## City of Klamath Falls

Review of Oregon Water Resources Department model for  
Fremont and Wocus wells, and the Conger well field  
Dr. Rob Annear, P.E., Cindy Bartlett, R.G., and Erin Dunbar

# OWRD Model Stream Depletion Results Constant & Variable Pumping

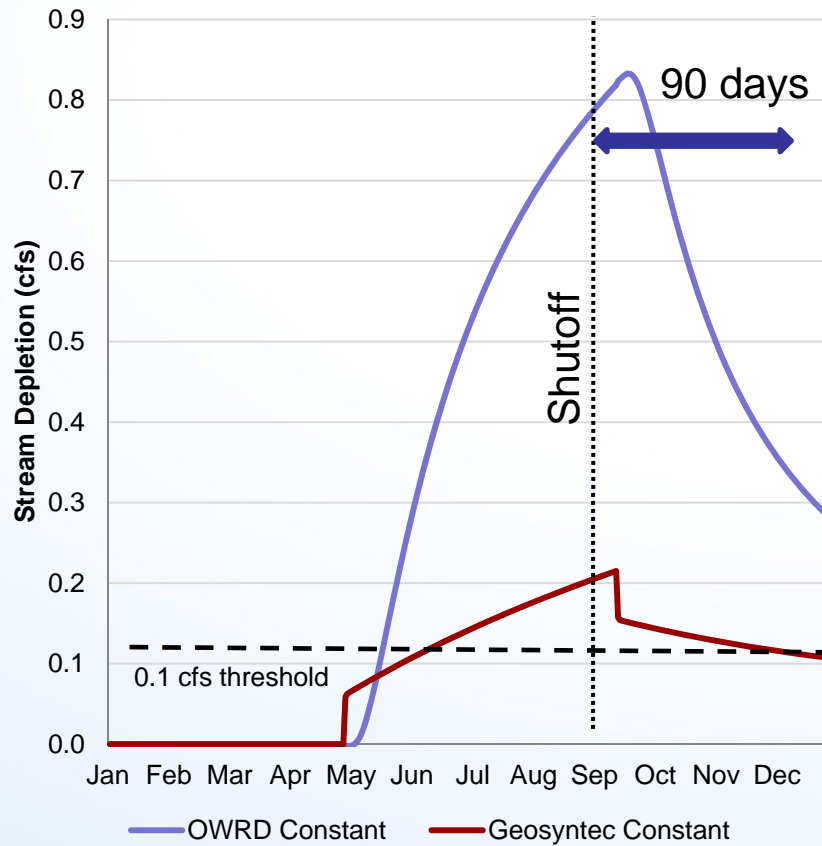
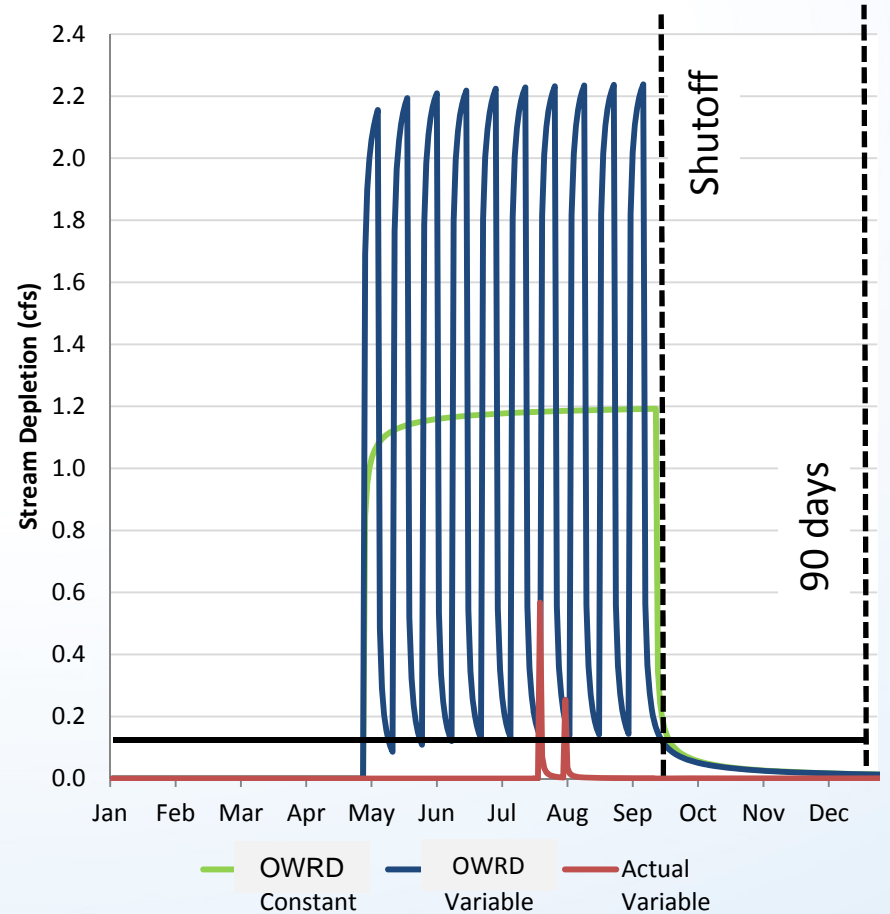
- OWRD Model Review Findings:
  - Assumes the only source of water to the well is coming from the nearby surface water.
  - The vertical hydraulic conductivity is **too high** relative to the horizontal hydraulic conductivity.
  - Assumes the wells are pumped as irrigation wells (not as municipal supply).
  - Assumes ½ of the maximum pumping rate (per water rights), instead of actual pumping rates.
  - **No** accompanying report to explain the basis for decision making for shutoff.
  - States it uses aquifer properties from USGS basin-wide model, but **values cannot be replicated**.

- **Modified the OWRD model**
  - Used USGS aquifer properties.
  - Used actual City pumping rates.
- **Results**
  - Almost no impact from Fremont and Wocus wells, and considerably less impact from the Conger well field to local stream depletion.
  - Model assumptions for municipal supply are flawed.
  - Use of alternate model was recommended.
